Subject: Borel Middle School HVAC Replacement
San Mateo - Foster City School District
Aedis Project No. 2021005
DSA Application #01-119557

ADDENDUM NO. 1

SHEET # AD1-
A2.02

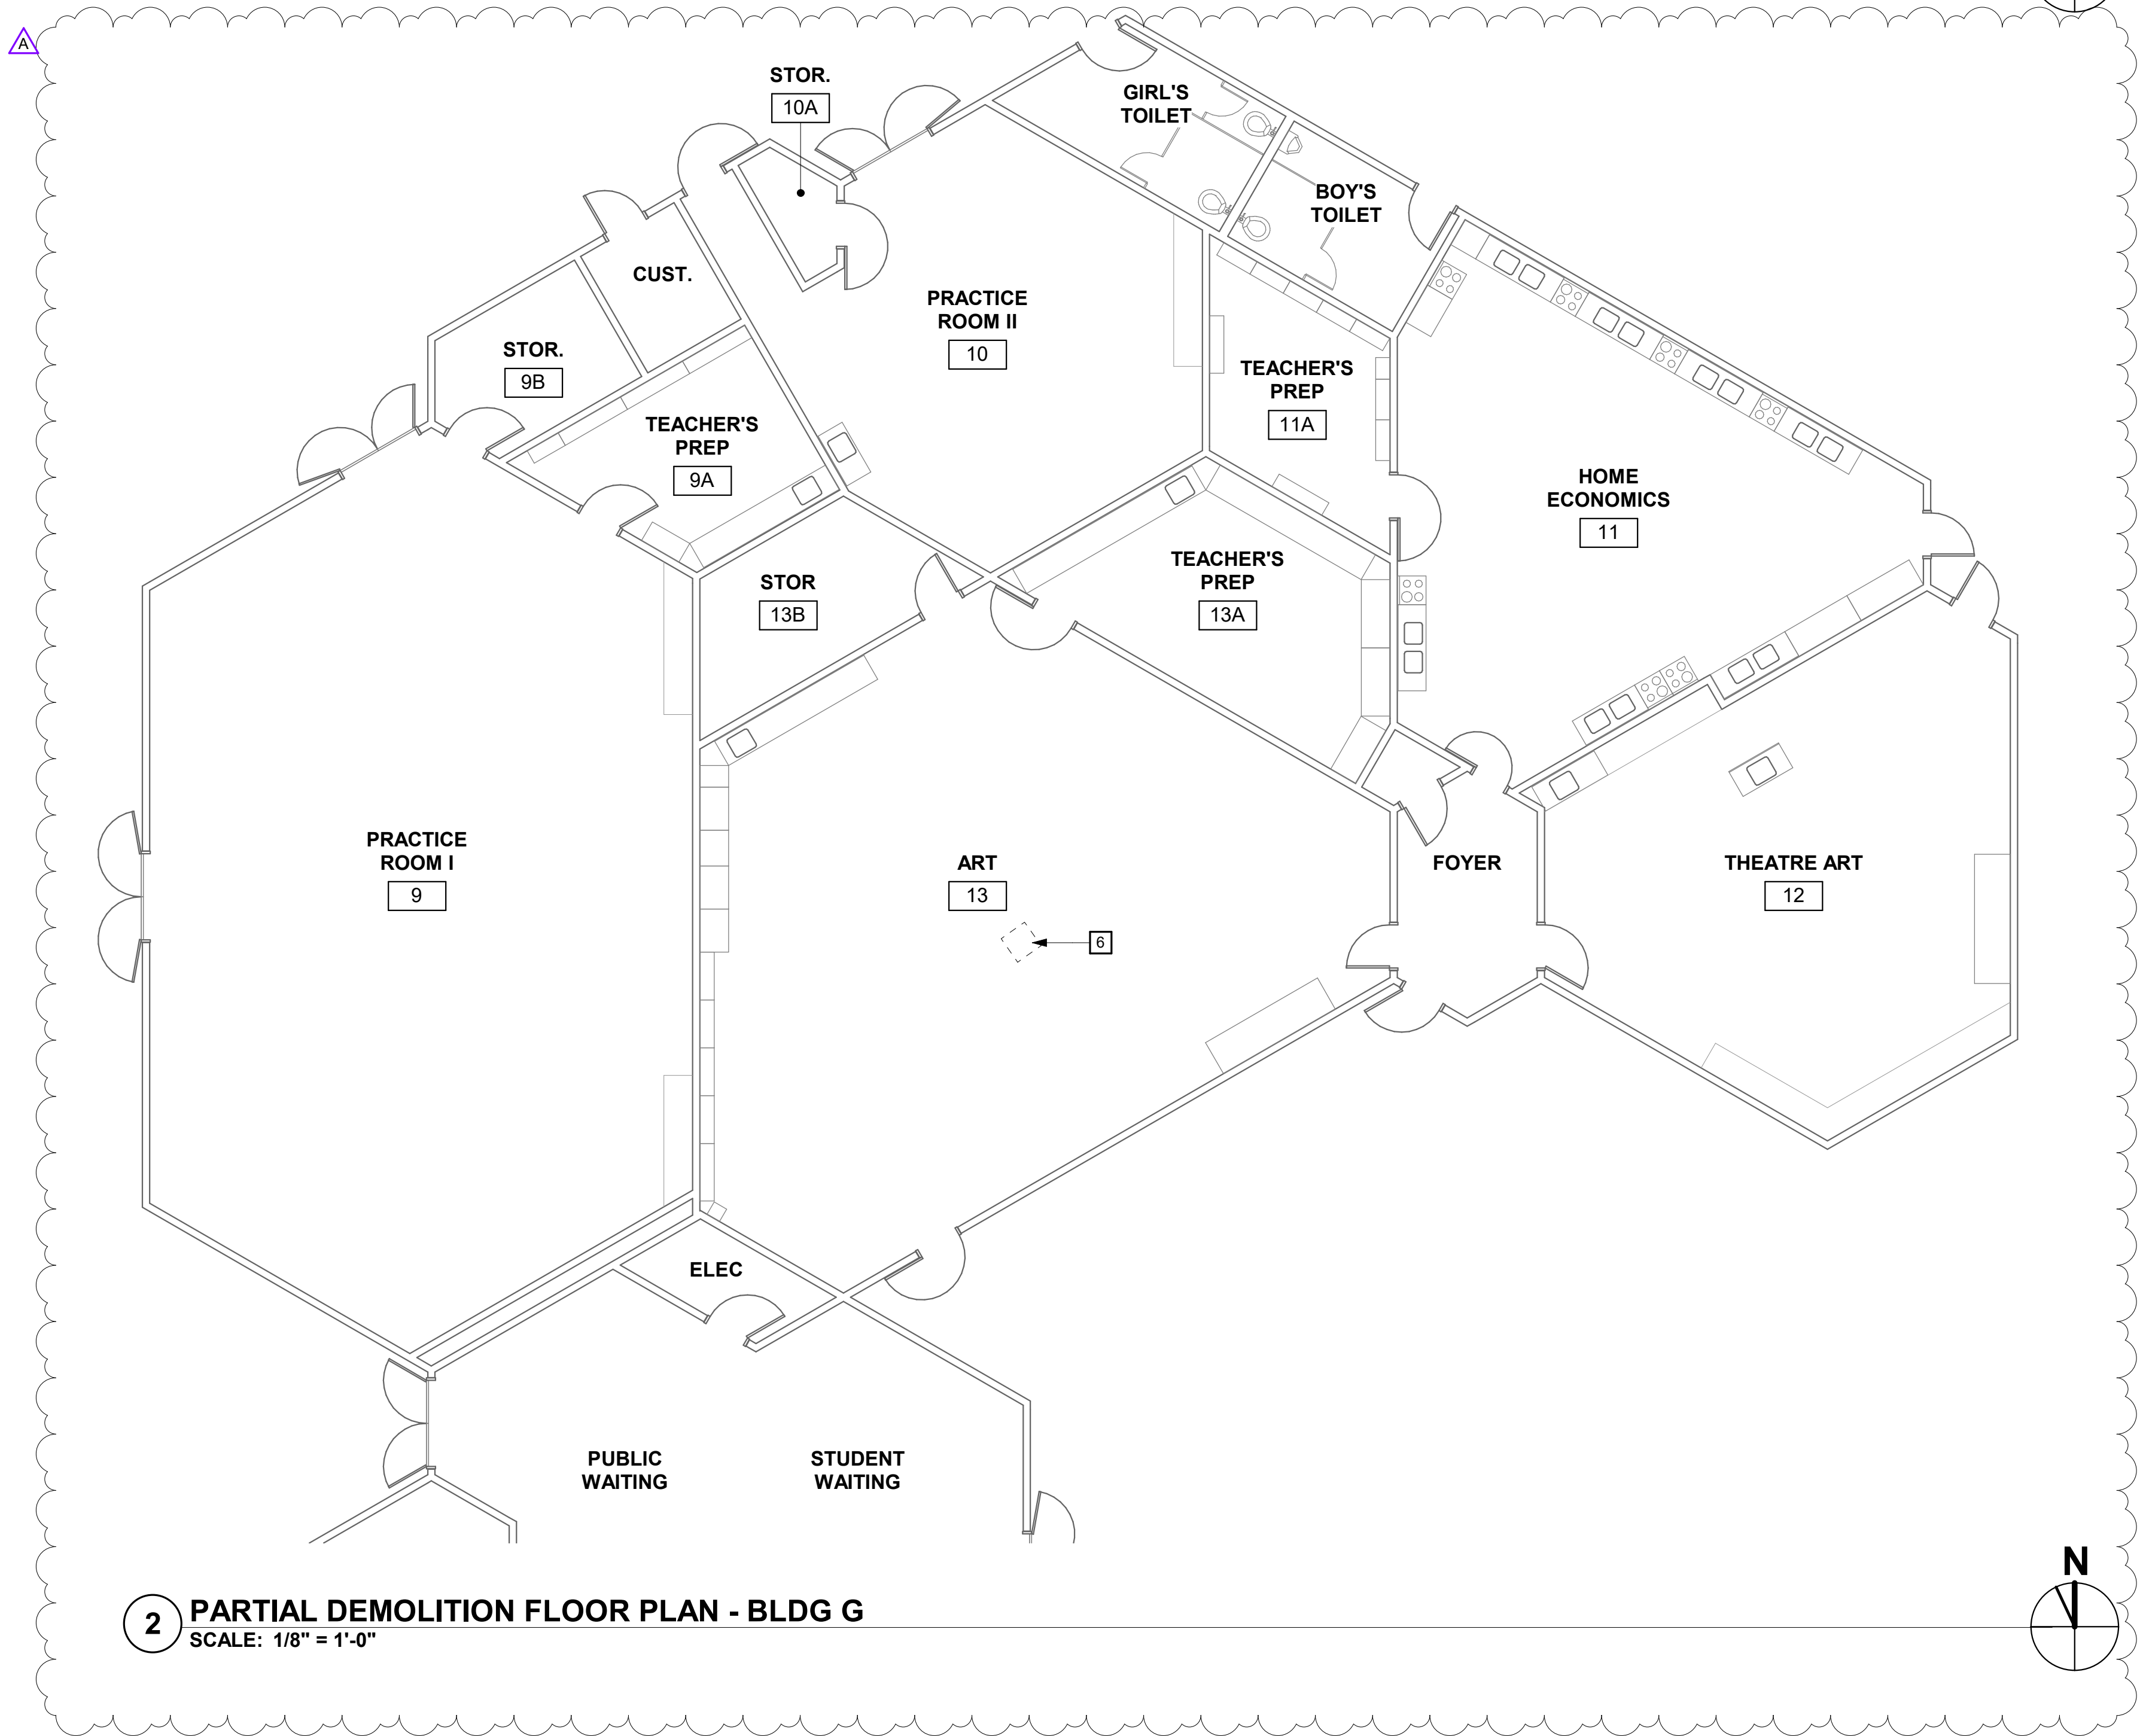
- Add: View 2/A2.02 PARTIAL DEMOLITION FLOOR PLAN – BLDG. G per AD1-A2.02
- Add: General Sheet Note #J per AD1-A2.02
- Revise: Remove and relocate as occurs keynote #5 at Demolition Floor Plan 1/A2.02 per AD1-A2.02
- Revise: Demolition Floor Plan Keynote #5 per AD1-A2.02
- Add: Demolition Floor Plan Keynotes #6 per AD1-A2.02

DATE 11/24/2021
JOB # 2021005.07
SHEET # AD1-
A3.02

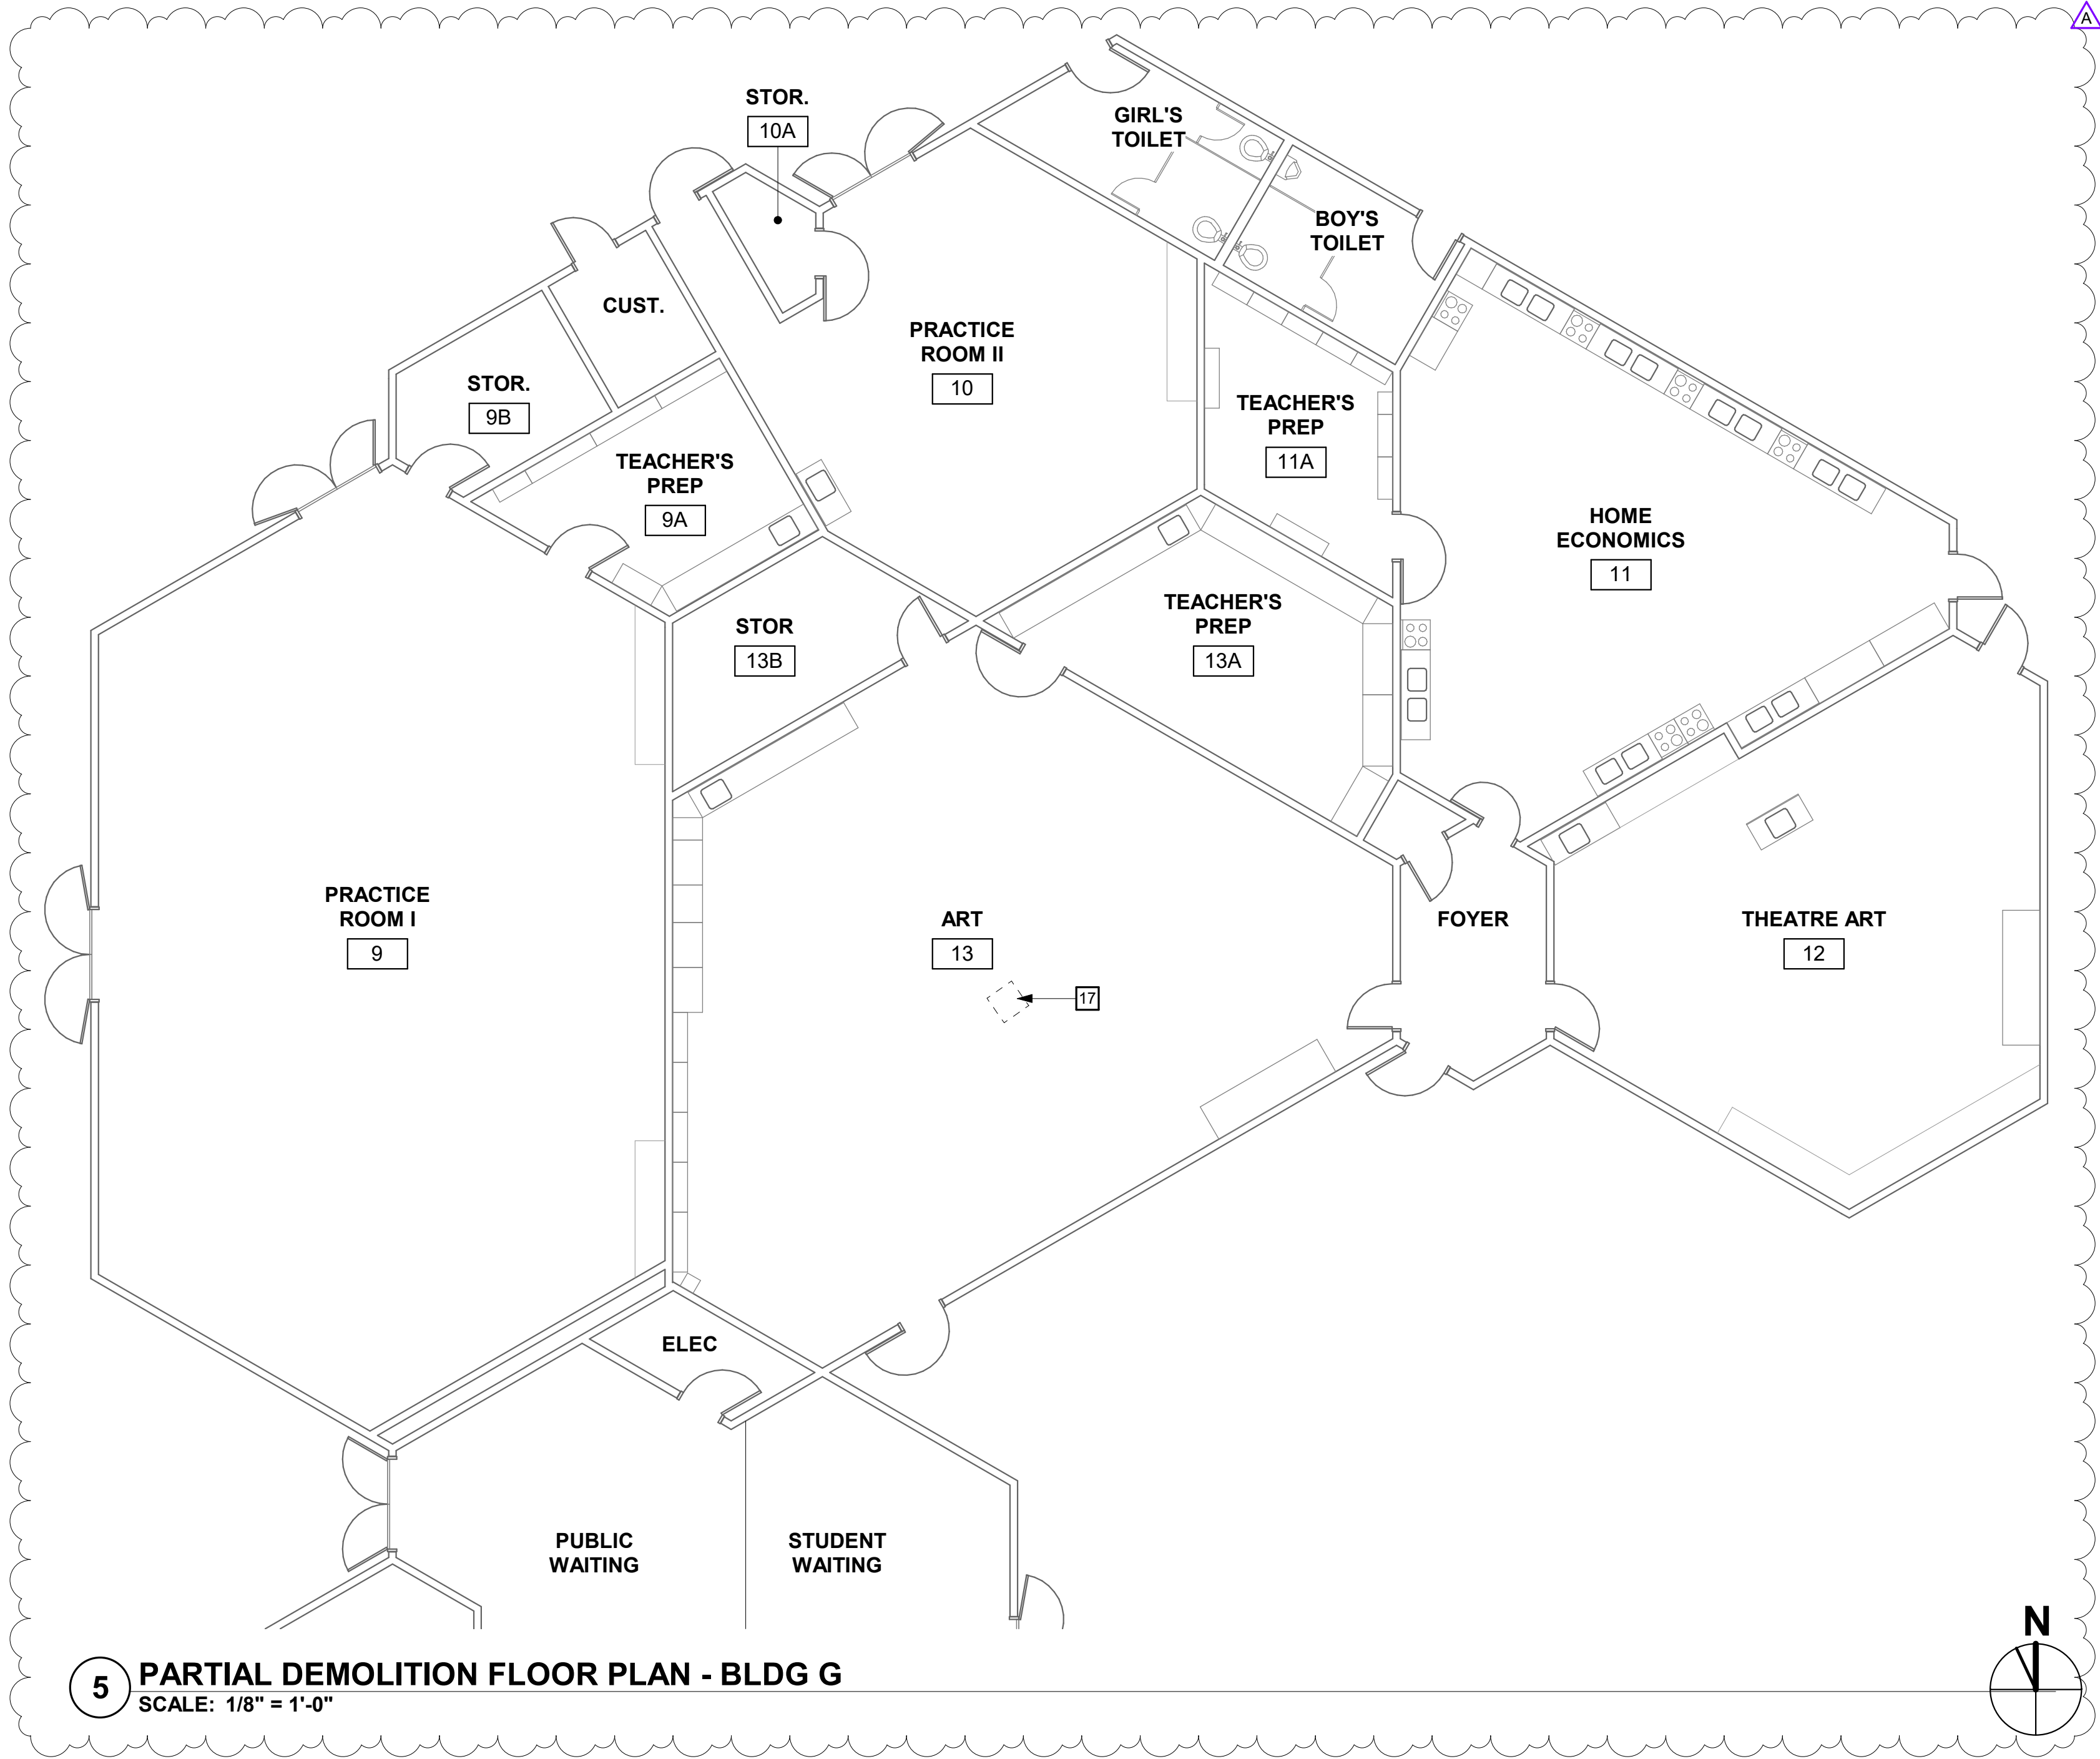
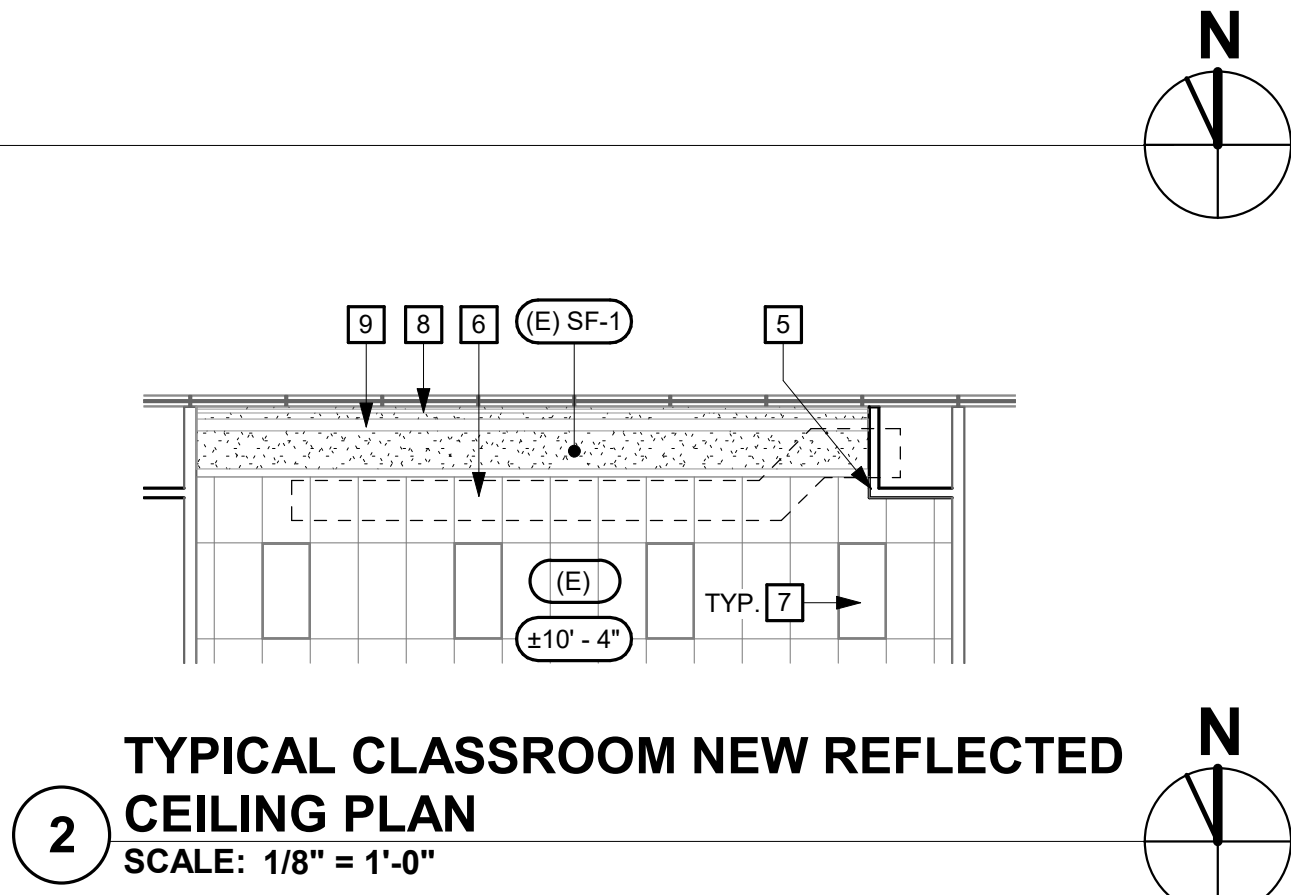
- Add: View 5/A3.02 New Partial Floor Plan – Bldg. G per AD1-A3.02
- Add: New Floor Plan & RCP Keynote #17 per AD1-A3.02
